**SOLICITATION AMENDMENT
MODIFICATION DE L'INVITATION**

Title - Sujet Office Space Fit-up	
Solicitation No. - N° de l'invitation EP916-200166/A	Amendment No. - N° modif. 007
Client Reference No. - N° de référence du client 20200166	Date 2019-06-12
GETS Reference No. - N° de référence de SEAG PW-\$\$\$FG-368-77183	
File No. - N° de dossier fg368.EP916-200166	CCC No./N° CCC - FMS No./N° VME
Solicitation Closes - L'invitation prend fin at - à 02:00 PM on - le 2019-06-19	Time Zone Fuseau horaire Eastern Daylight Saving Time EDT
F.O.B. - F.A.B. Plant-Usine: <input type="checkbox"/> Destination: <input checked="" type="checkbox"/> Other-Autre: <input type="checkbox"/>	
Address Enquiries to: - Adresser toutes questions à: Dagenais, Nathalie	Buyer Id - Id de l'acheteur fg368
Telephone No. - N° de téléphone (613) 859-0695 ()	FAX No. - N° de FAX () -
Destination - of Goods, Services, and Construction: Destination - des biens, services et construction:

THE AMENDMENT NO.007 IS RAISED FOR THE FOLLOWING REASON;

ADDENDUM No. 7

1 MECHANICAL HVAC DEMOLITION
ADD8-M-SK1 1:100

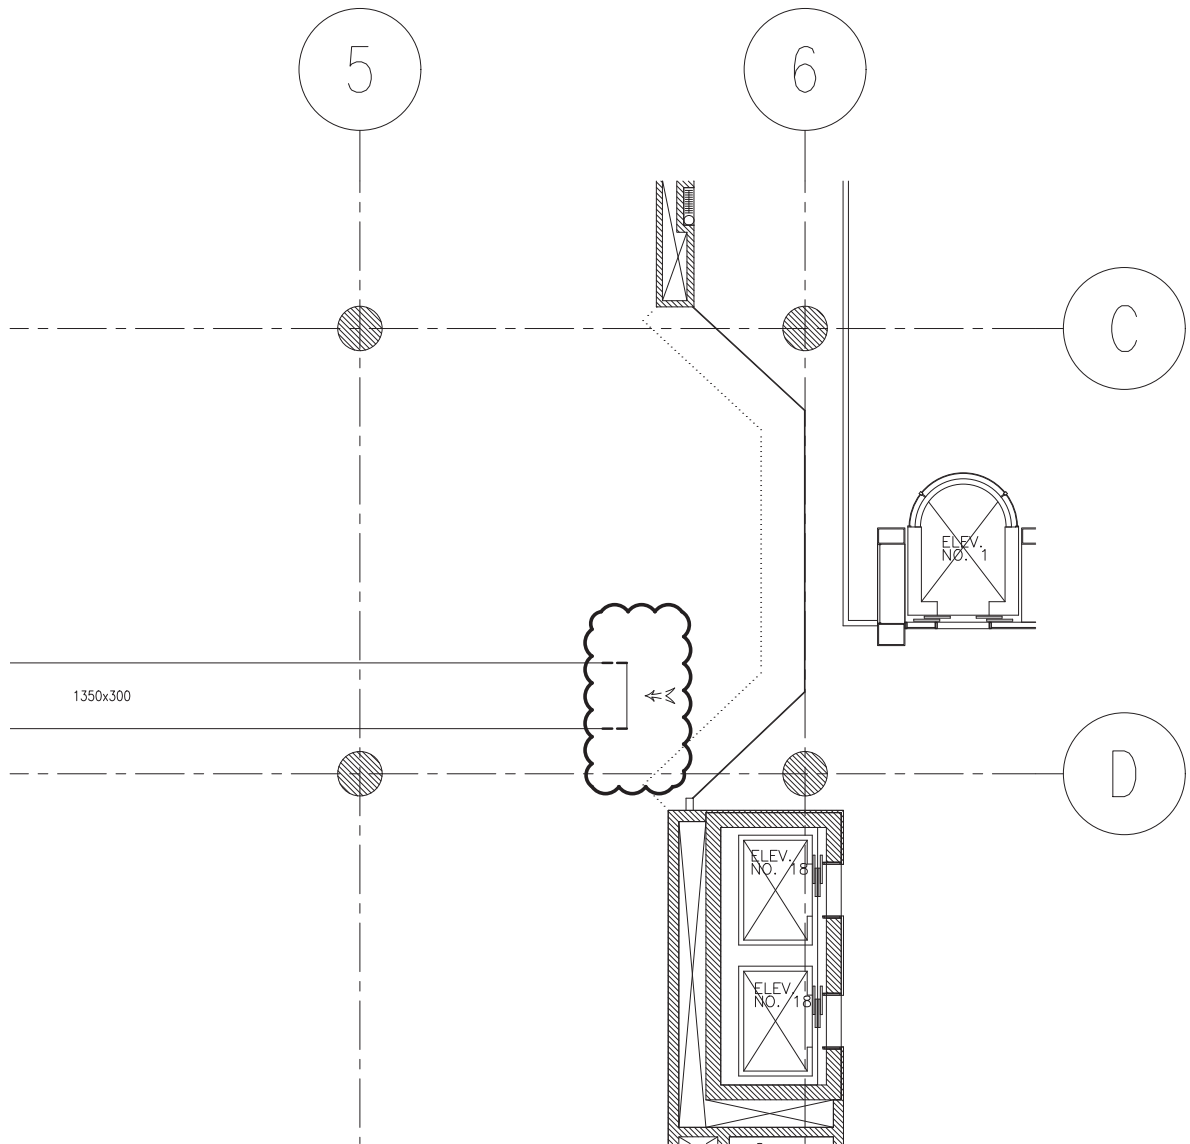
3 M301 MECHANICAL LEVEL C2 HVAC DEMOLITION & ATTACHED SKETCH ADD8-M-SK1

- .1 Remove existing ductwork as indicated.

1 MECHANICAL HVAC NEW WORK
ADD8-M-SK2 1:100

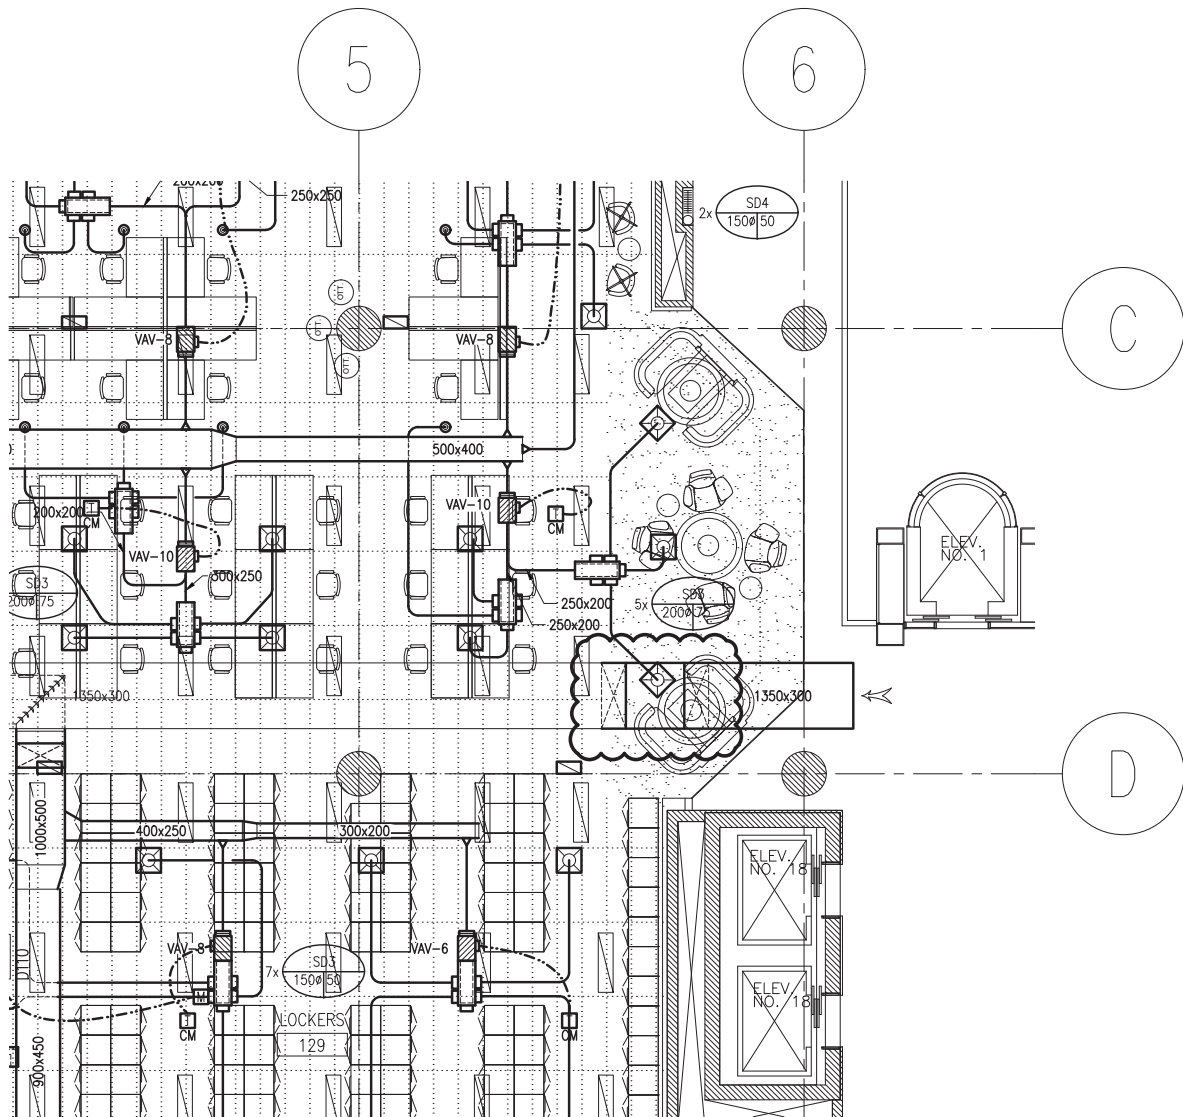
4 M302 MECHANICAL LEVEL C2 HVAC NEW WORK & ATTACHED SKETCH ADD8-M-SK2

- .1 Offset new ductwork as indicated to bypass existing piping.
